Plan Commission

Agenda

Monday, February 26, 2018	7:00 PM	De Pere City Hall Council Chambers
----------------------------------	----------------	---

- ITEM 6:** Recommendation regarding a Site Plan for a new business and parking area called McDonald's at 1022 Main Avenue (Parcel WD-708-X-1-2). Submitted by Landform Professional Services LLC.

SHEET NO. C3.1

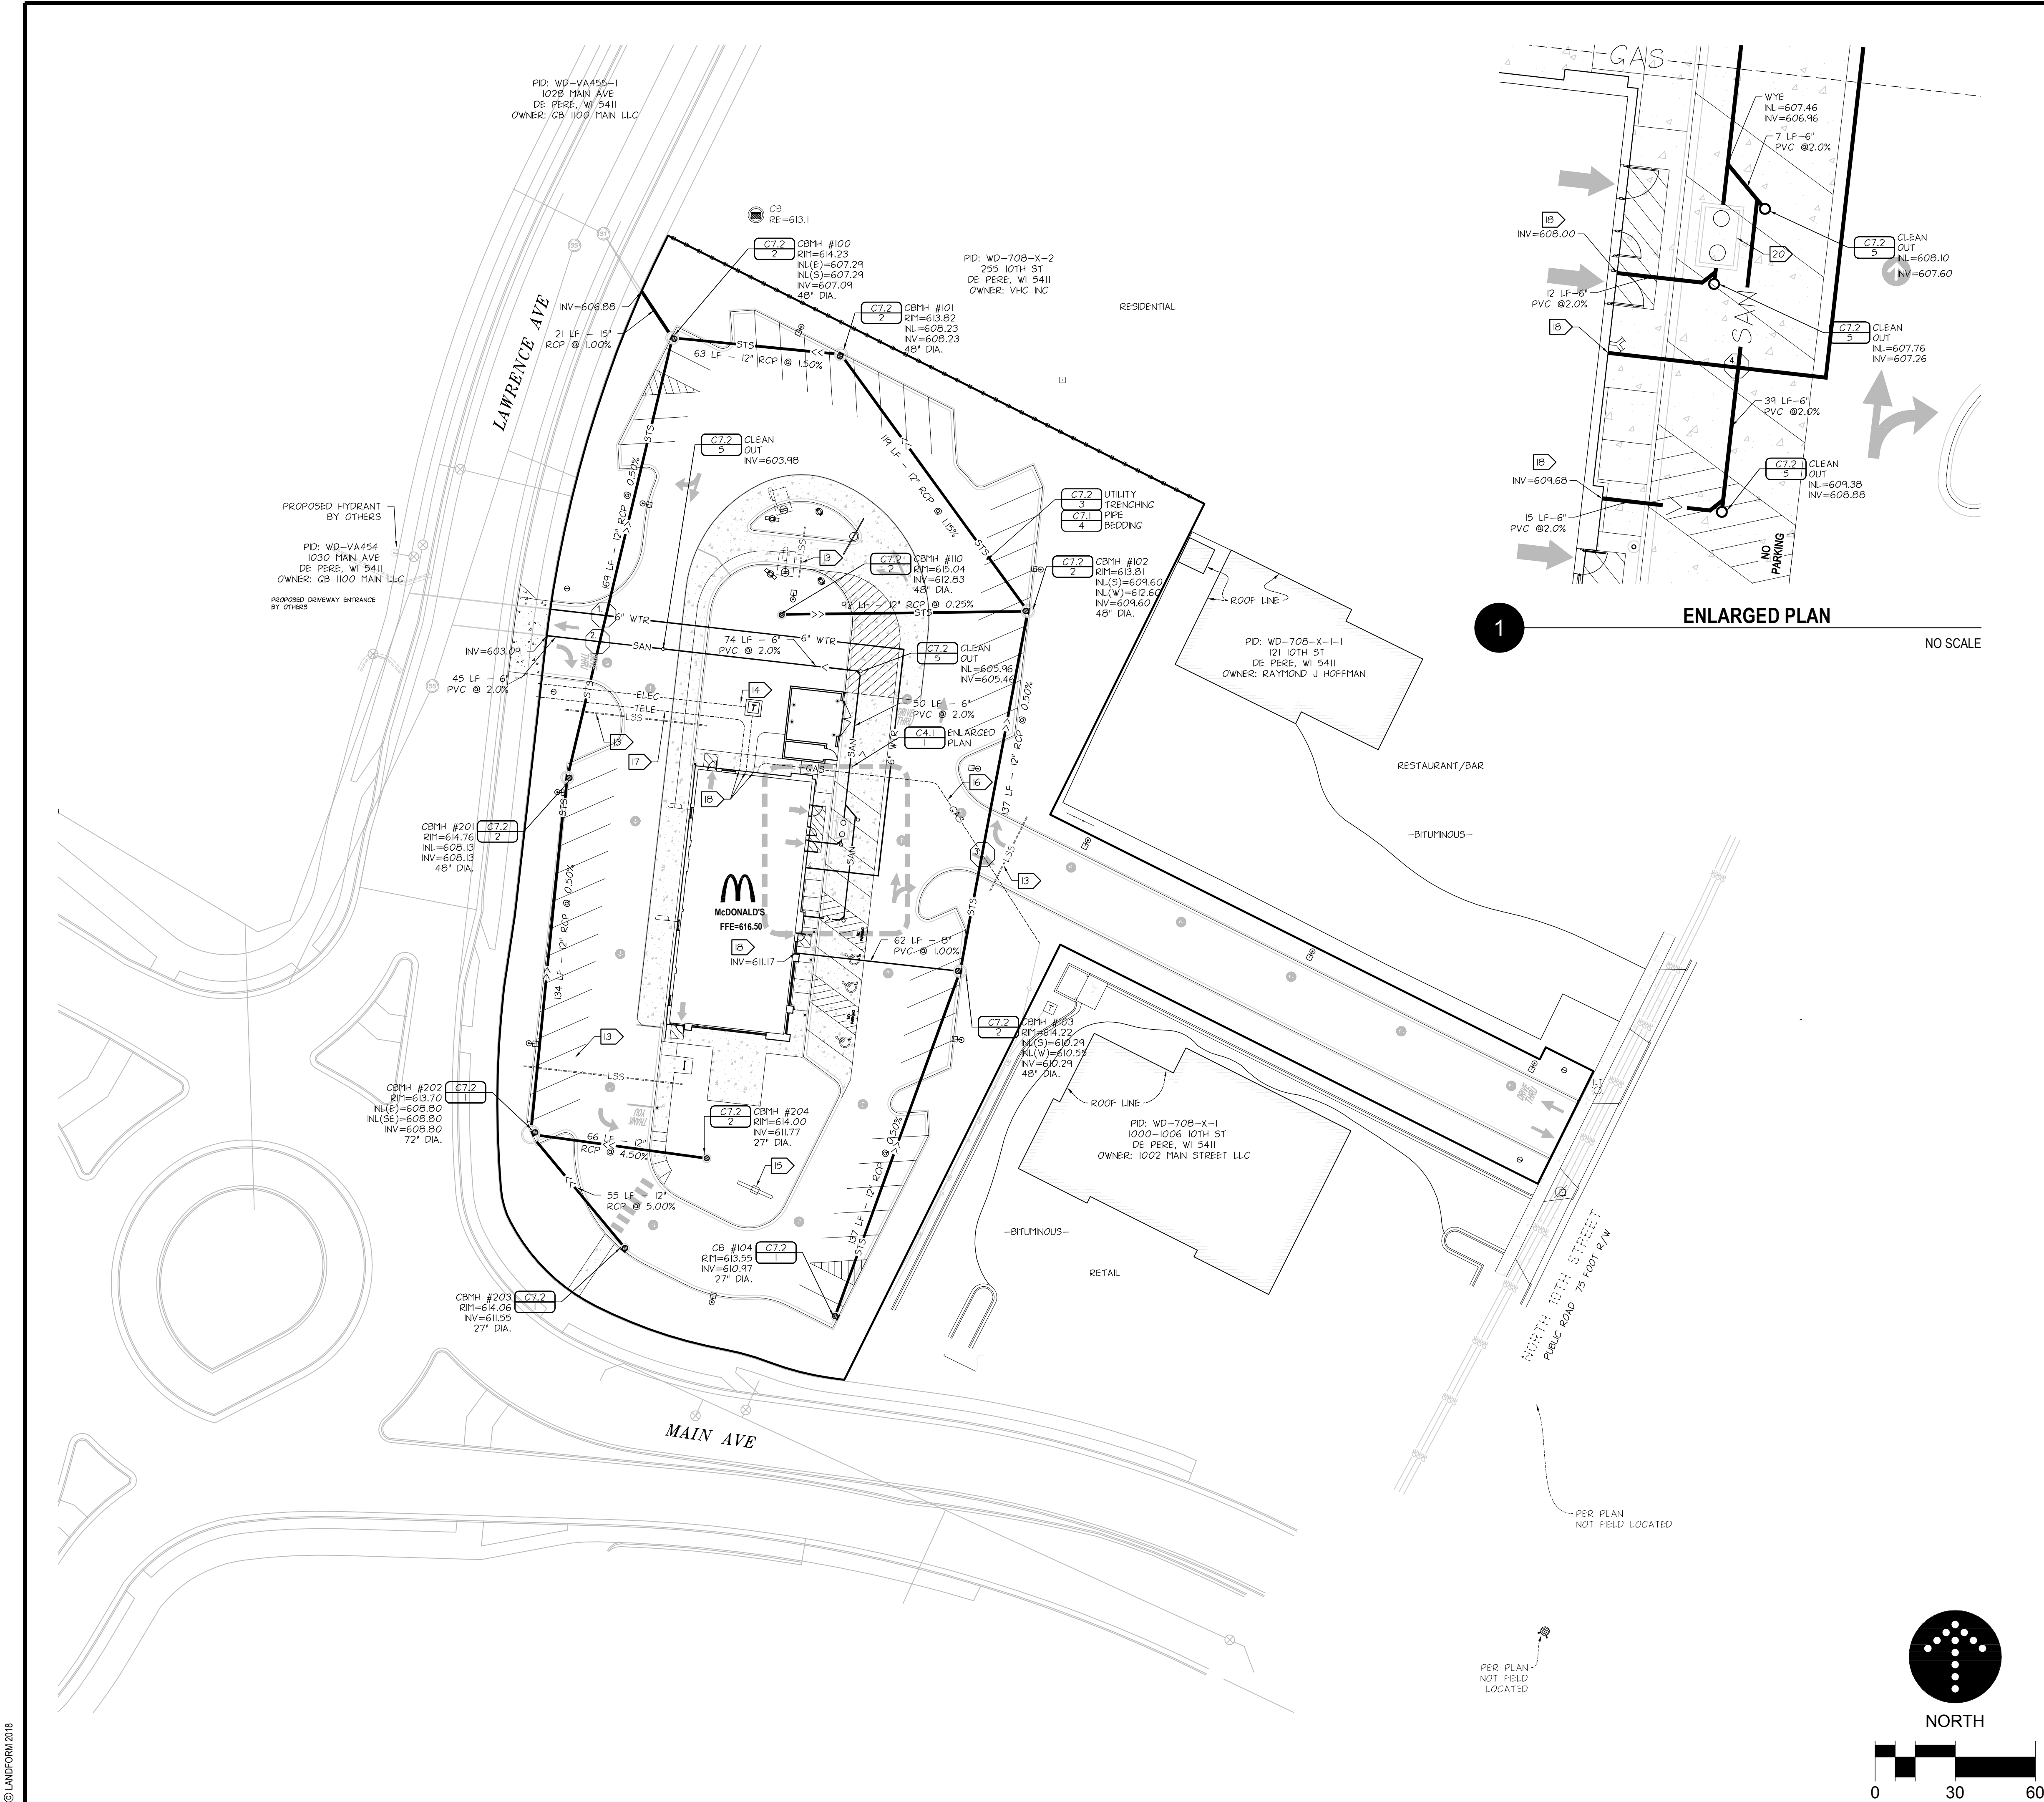
10. *On sheet C3.1: Under paving notes item #21c it is recommended that all concrete surfaces for drives, aprons and exterior slabs be 8-inch concrete. The concrete apron and adjacent concrete sidewalk will be 8-inch concrete.*

Revised on sheet C3.1

PROJECT NO.
C4.1

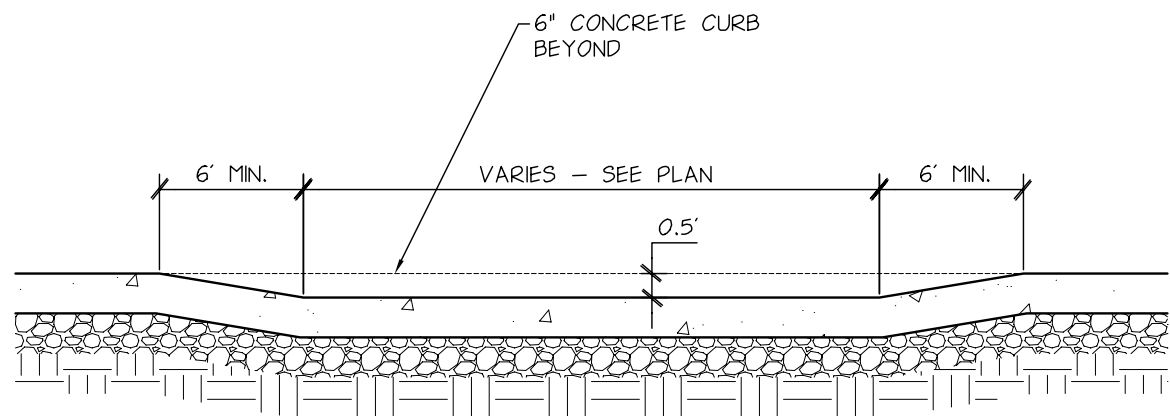
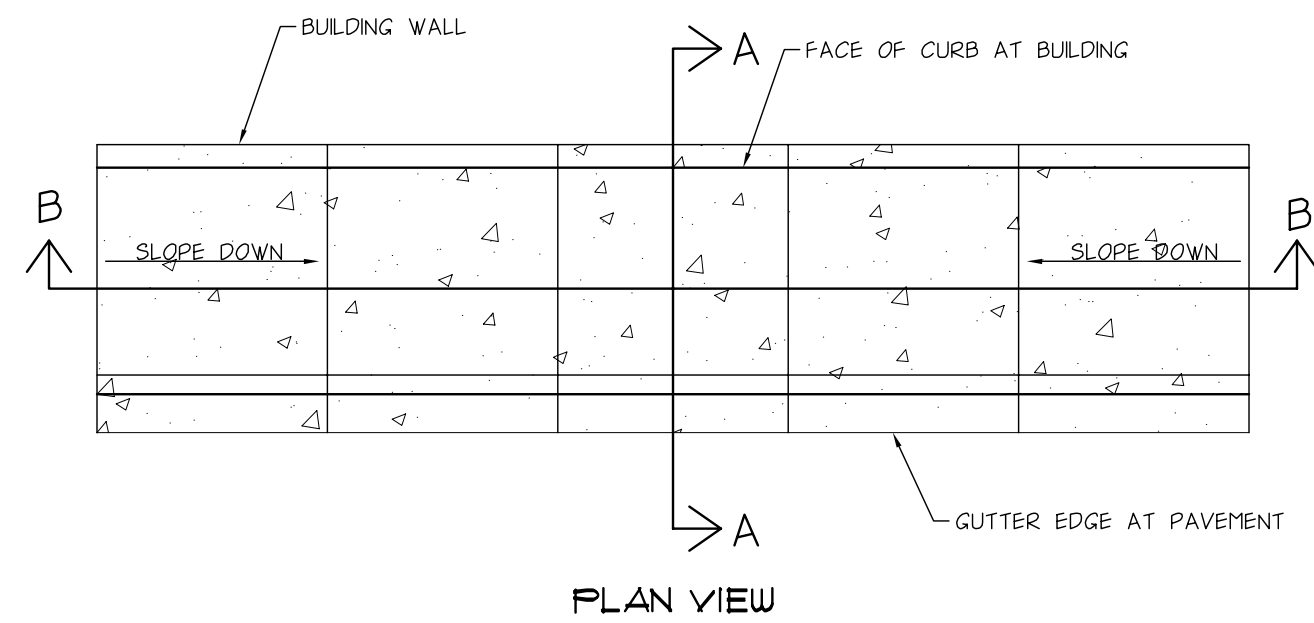
11. *On sheet C4.1: Show new lateral locations in the City right-of-way.*

12. *On sheet C4.1: CBMH #201 - should the INL(S) be 607.93 not 607.29.*

13. *On sheet C4.1: The pipe between CBMH #210 and CBMH #201 has a slope of 0.30% not 0.25%.*

14. *On sheet C4.1: The storm sewer lateral will be connected at the right-of-way line. The lateral will be provided to the right-of-way line as part of the roundabout/Lawrence Ave construction.*

15. *On sheet C4.1: Utility Notes comment #9 should include that for work in the right-of-way call the City of De Pere Public Works at 920-339-4061 for an excavation permit.*

16. *On sheet C4.1: Since the proposed water service is larger than a 4-inch line it will need additional testing (i.e. pressure test, safe sample test).*

Revised on sheet C4.1

Storm sewer has been revised on sheet C4.1

Storm sewer has been revised on sheet C4.1

Storm sewer has been revised on sheet C4.1

Revised on sheet C4.1
